**NOTICE OF ADDENDUM
ADDENDUM NO. 2**

**CONTRACT NO. 7939
MADISON MUNICIPAL BUILDING - RENOVATION**

This addendum is issued to modify, explain or correct the original Drawings, Specifications, or Contract Documents and is hereby made a part of the contract documents.

3 CURTAIN WALL HEAD DETAIL
A353 3" = 1'-0"

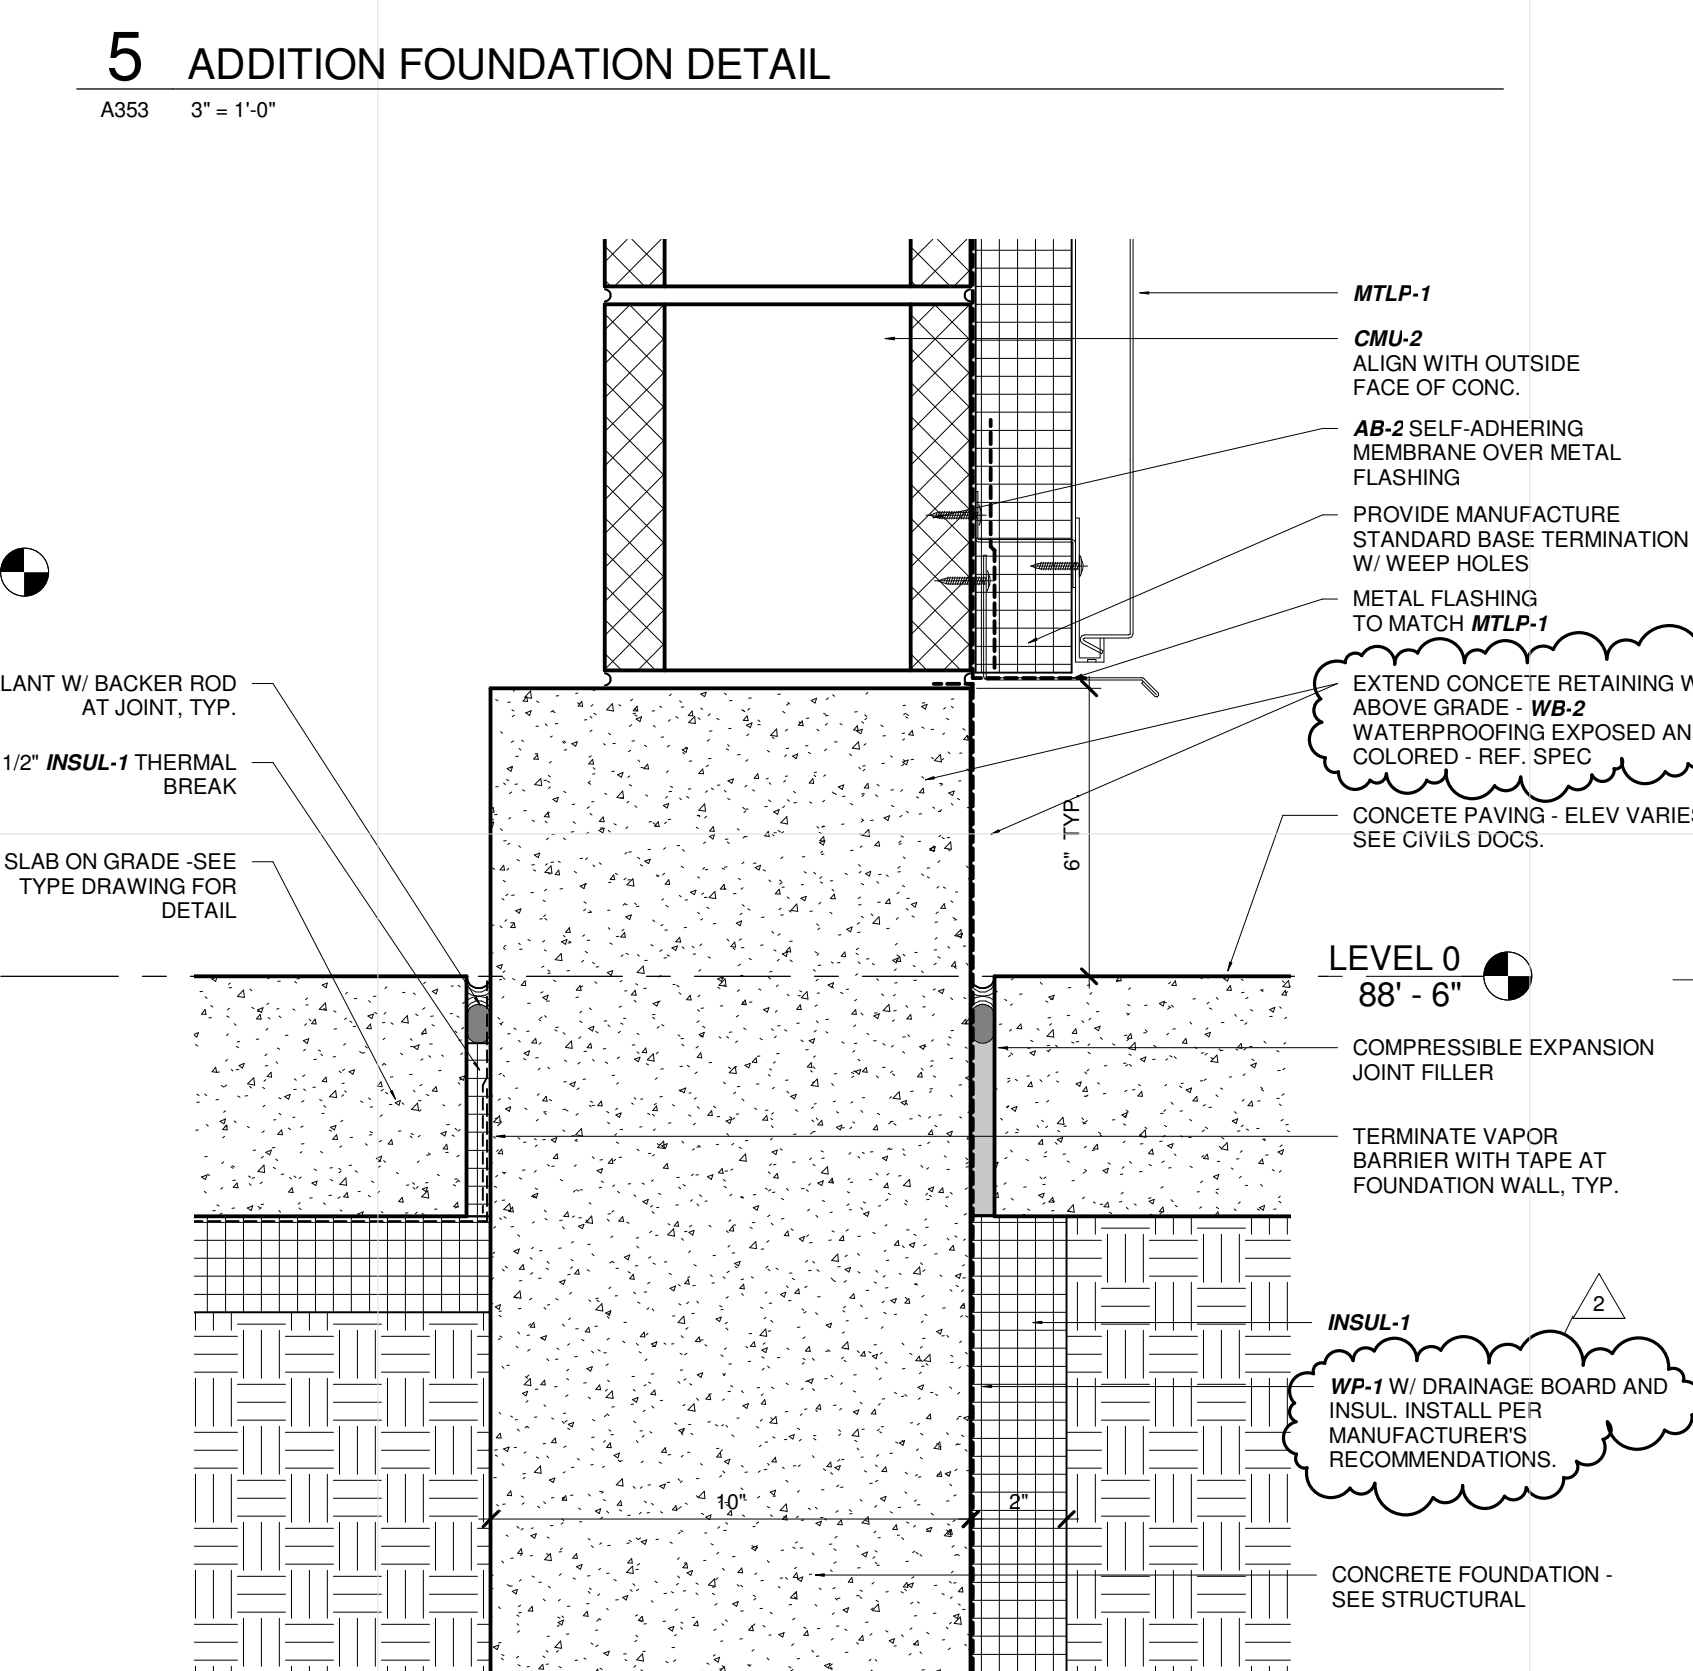
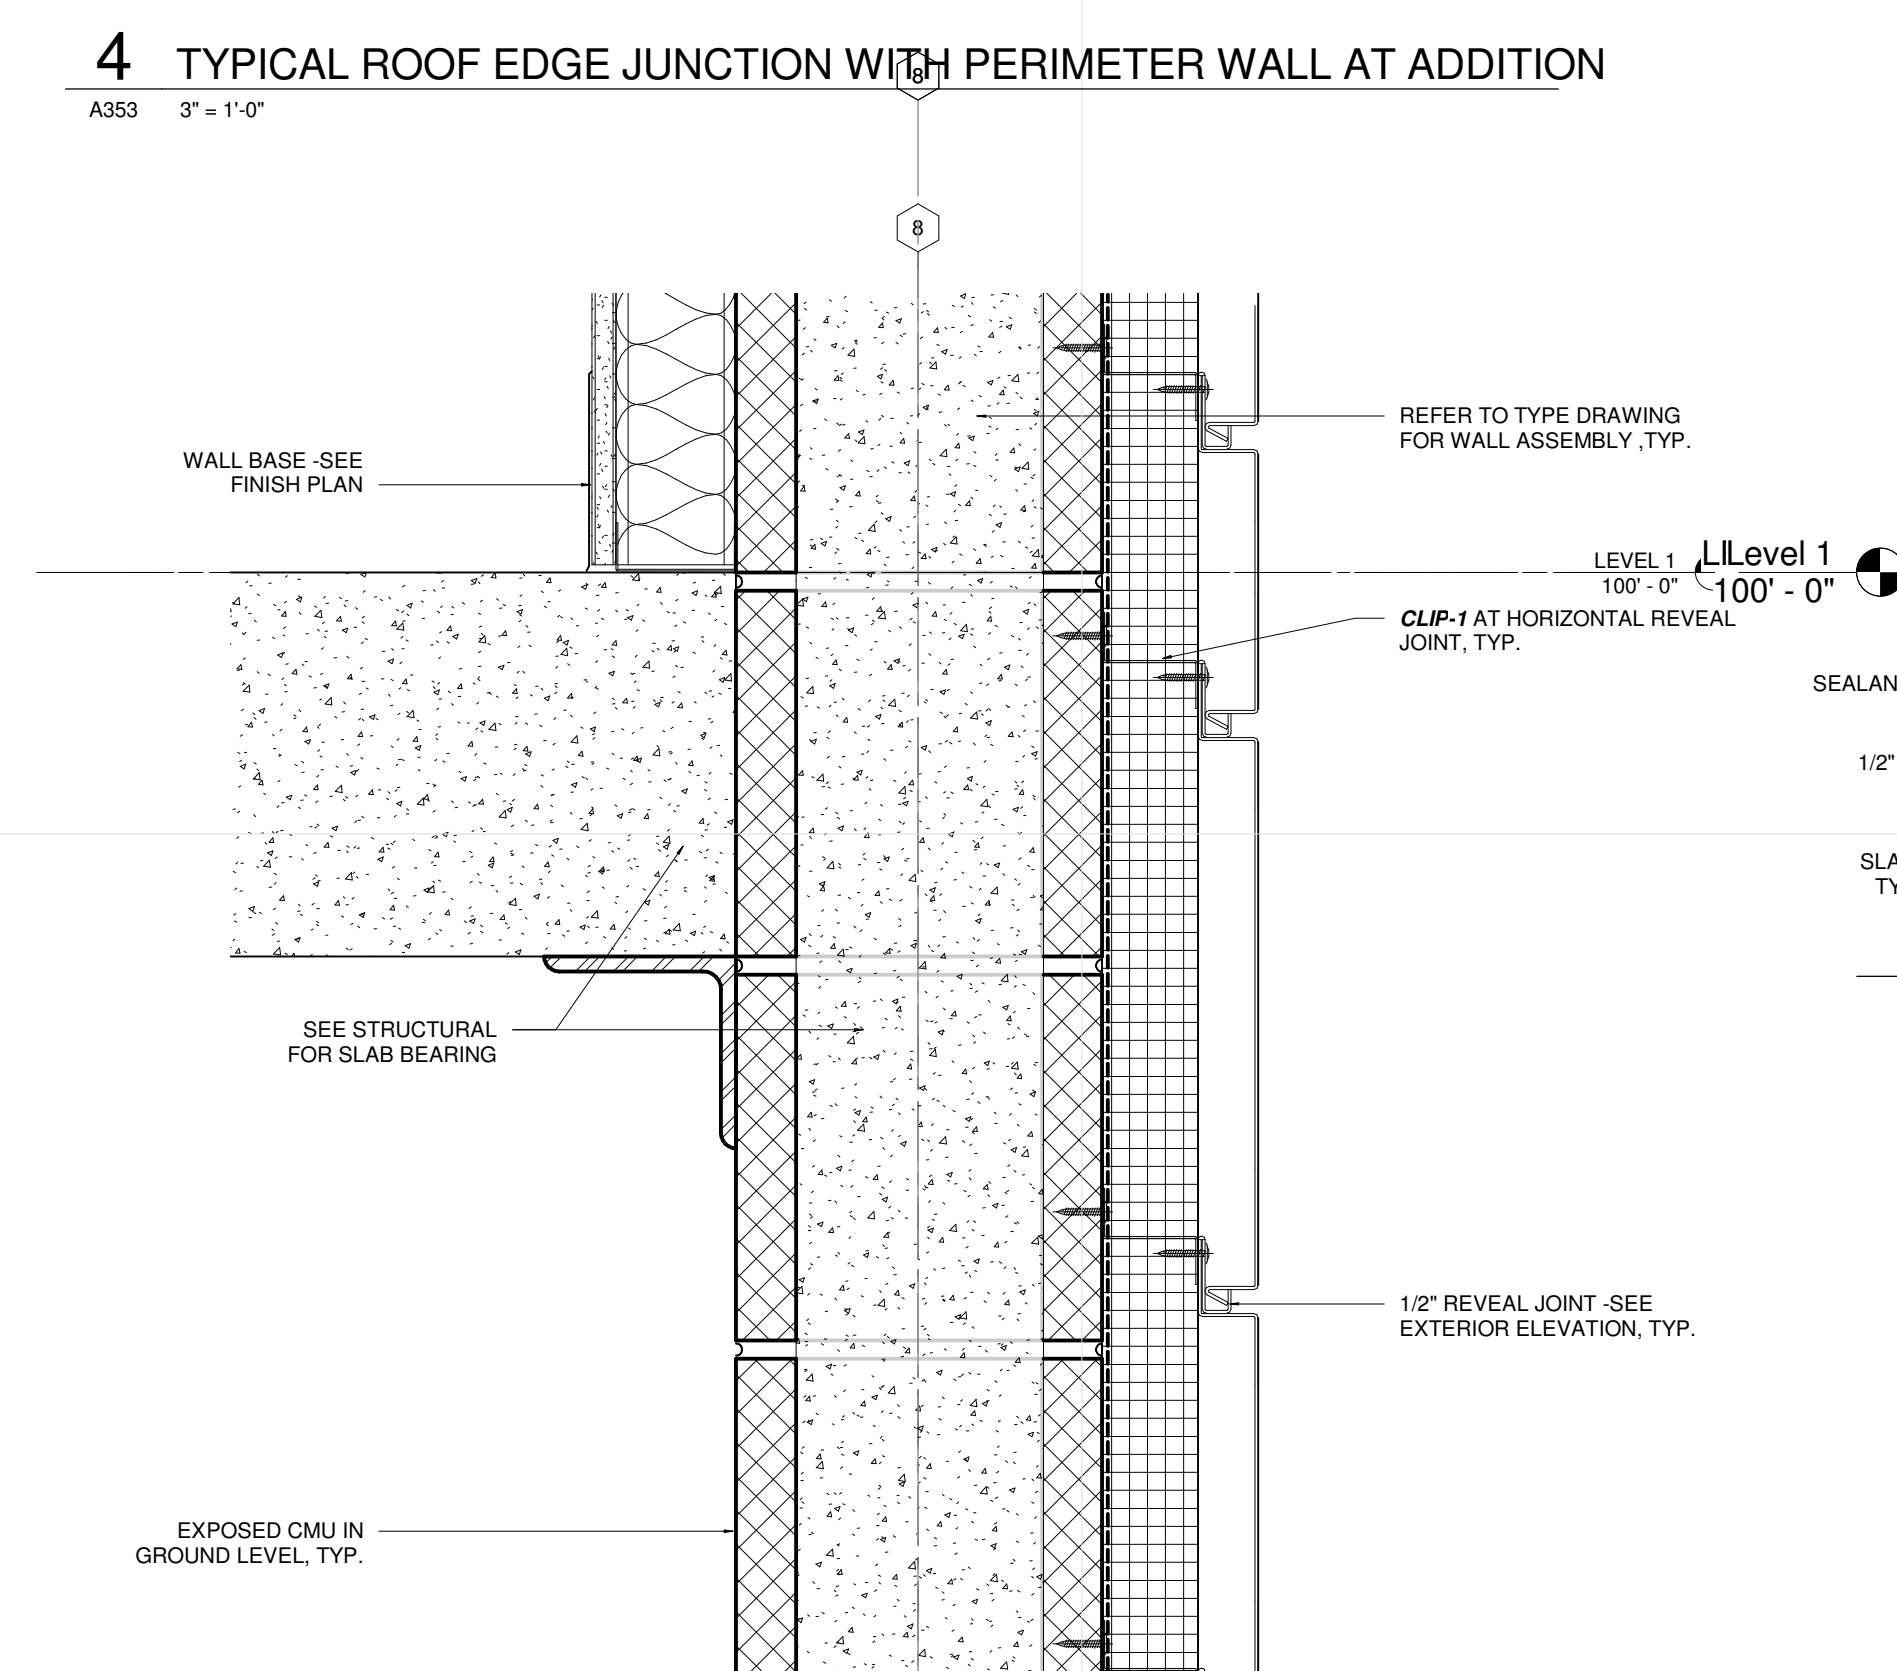
1. Detail 1/A192 Revised to center vestibule on exterior doors.
2. Details 7 and 8/A301. Revised details to clarify waterproofing notes.
3. Details 5,7 and 9/A353. Revised details to clarify waterproofing notes.
